**ADDENDUM  
NO. 1**

**March 17, 2025**

**PORTER LAKES ELEMENTARY SCHOOL  
ADDITION, RENOVATIONS, AND RELATED WORK  
Hebron, IN 46341**

This Addendum consists of Pages ADD 1-1, Specification Section 00 34 10 – Responsible Bidding Practices, and attached Addendum No. 1 from Gibraltar Design, Inc. dated March 14, 2025 and consisting of 6 pages, Specification Section 07 41 13 – Aluminum Roofing and 28 drawings.

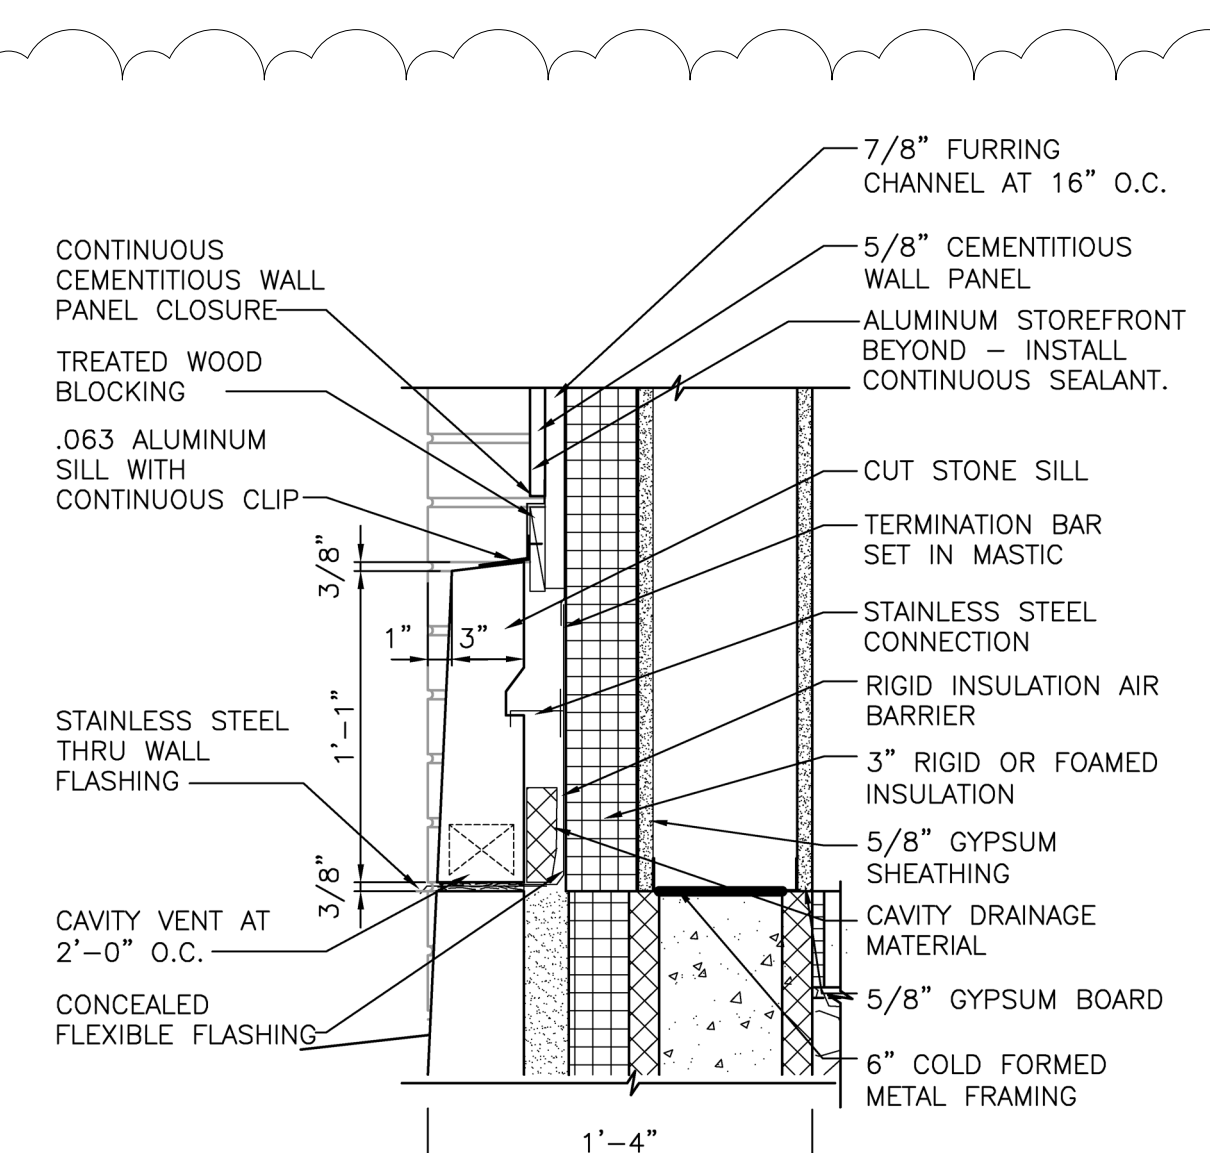
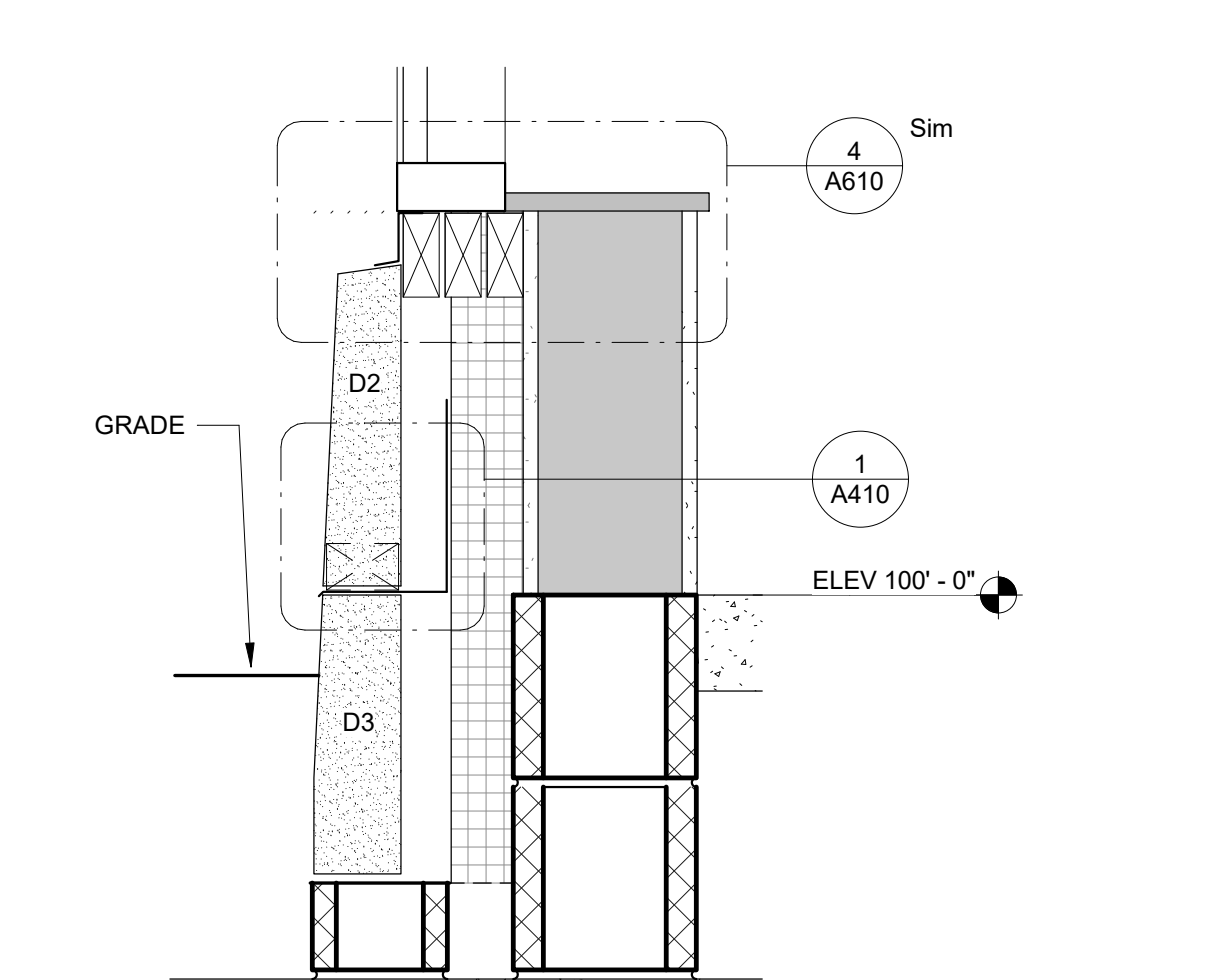
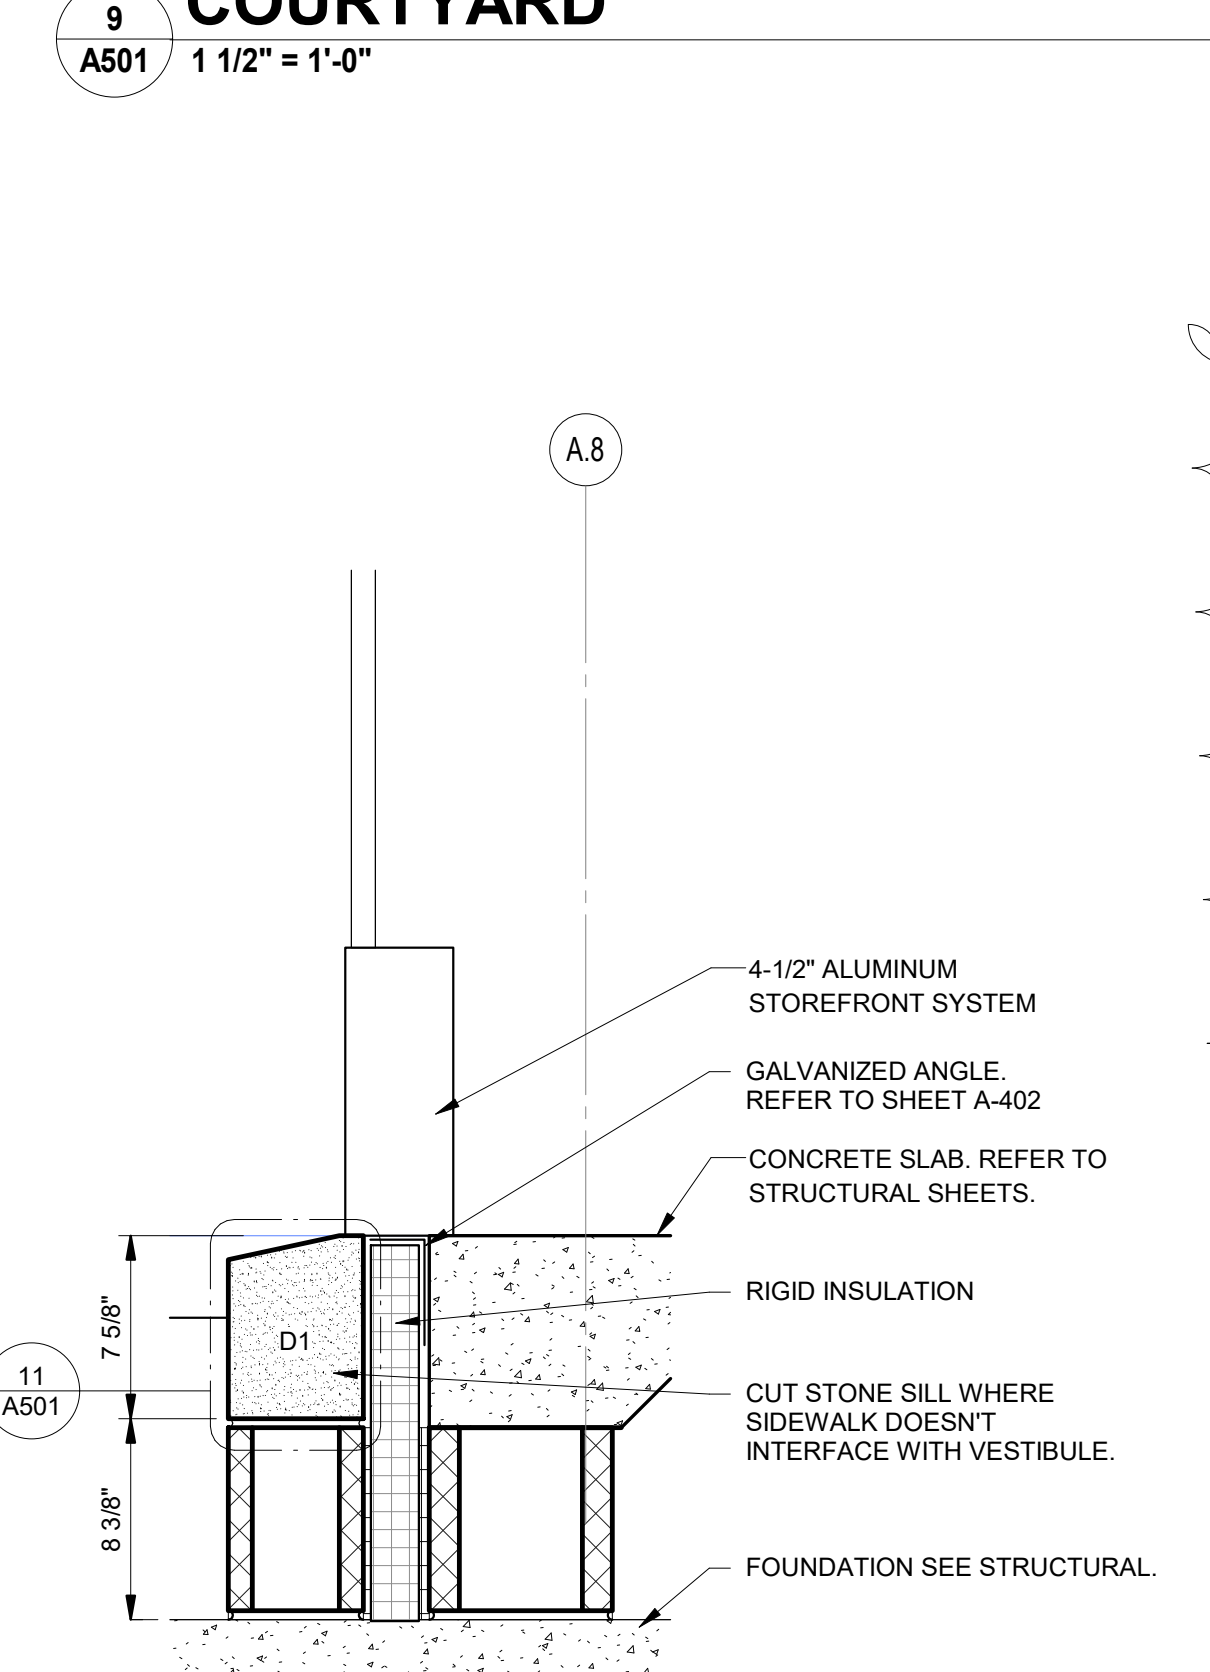
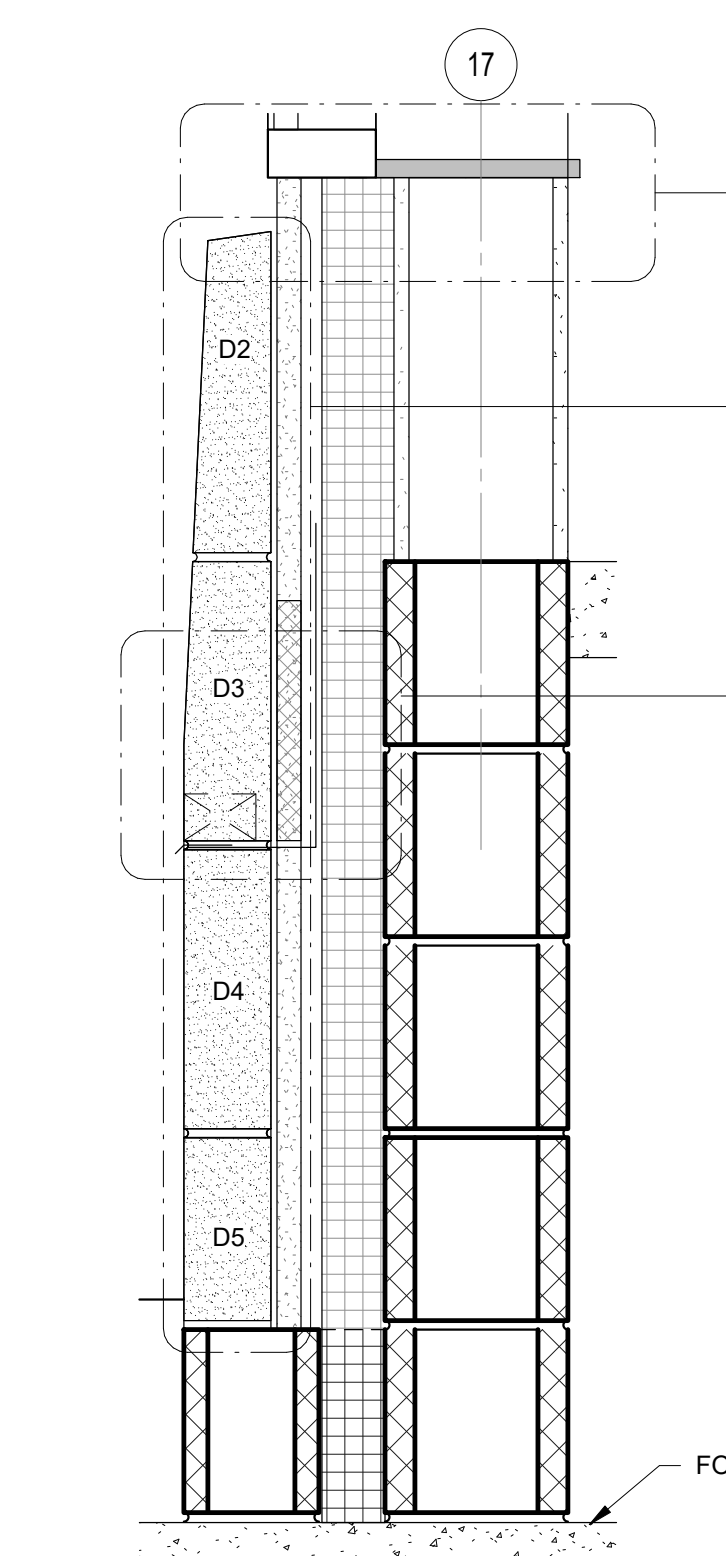
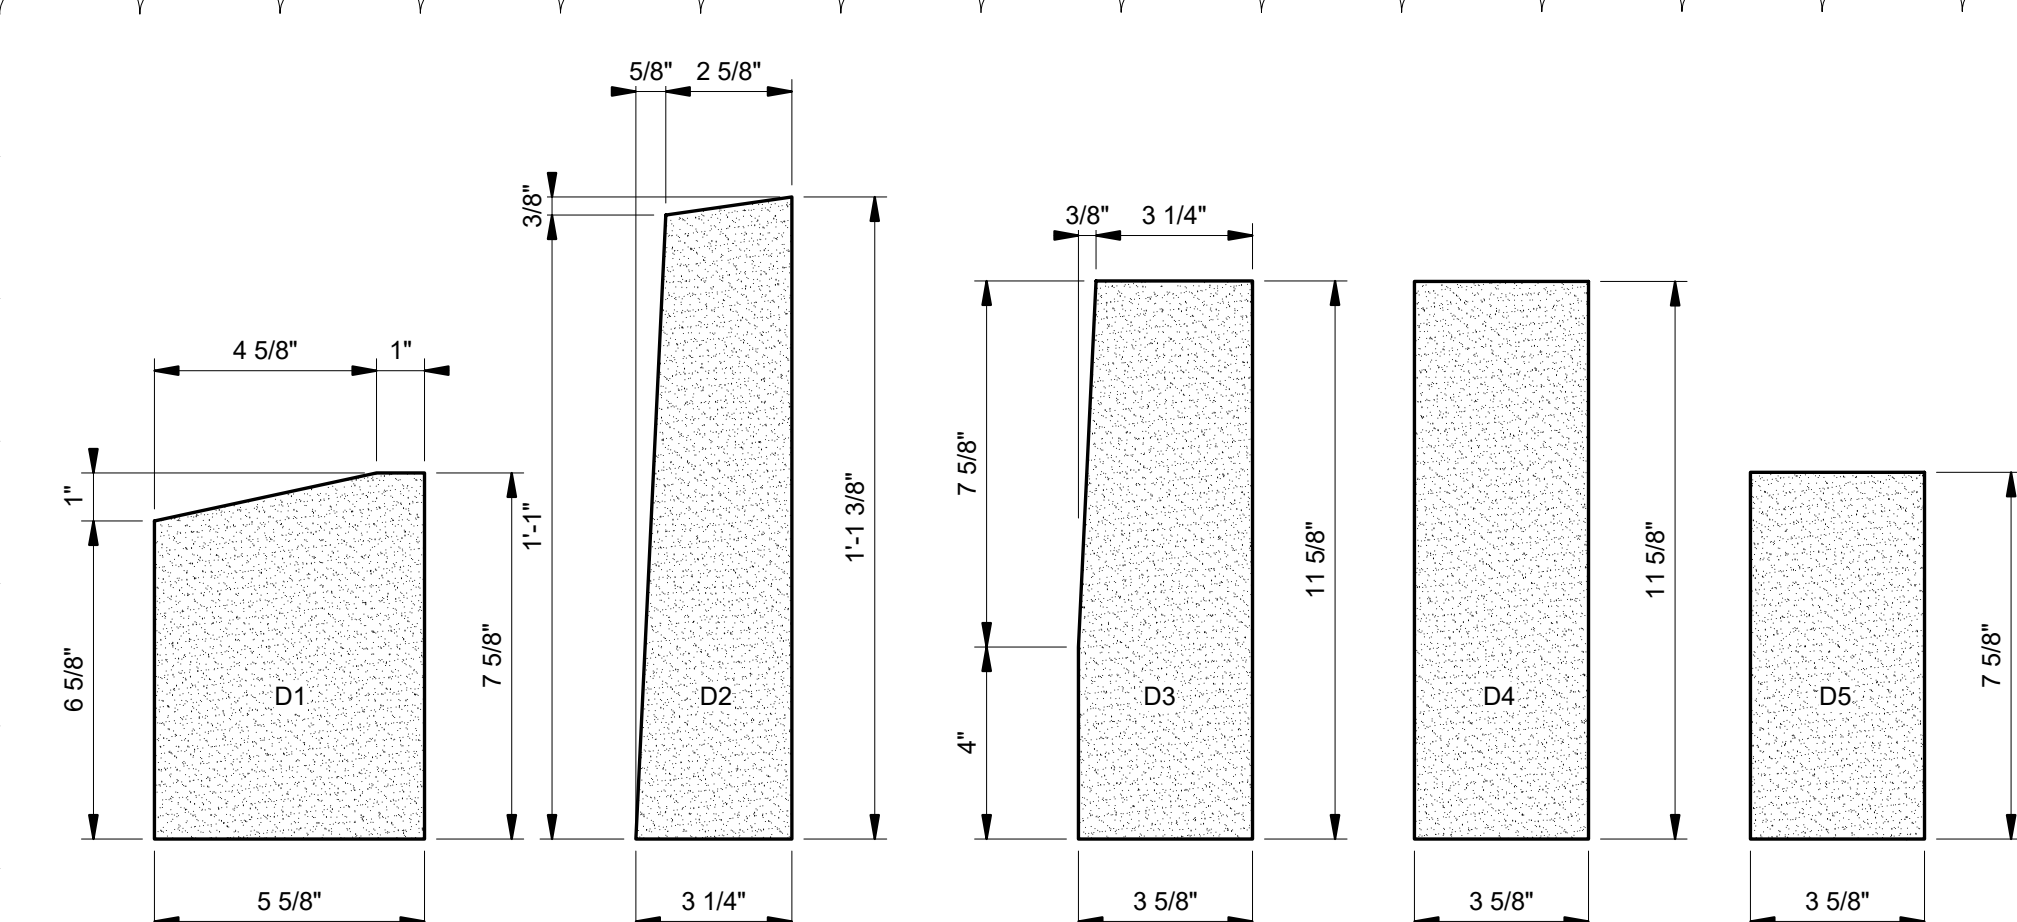
- A. Refer to revised, full-size drawing, included in this Addendum, for revisions.
  - 1. Detail 3 removed
  - 2. Detail 9 renumbered to detail 3
  - 3. Detail 5 modified for insulation and galvanized angle.
  - 4. Detail 6-8 includes cut stone type marks, and are retitled for location clarification.
  - 5. Detail 9 new section at new courtyard windows
  - 6. Detail 10 includes cut stone type mark A3
  - 7. Detail 11 includes cut stone type numbers and additional stone pieces.
  - 8. Detail 12 was added
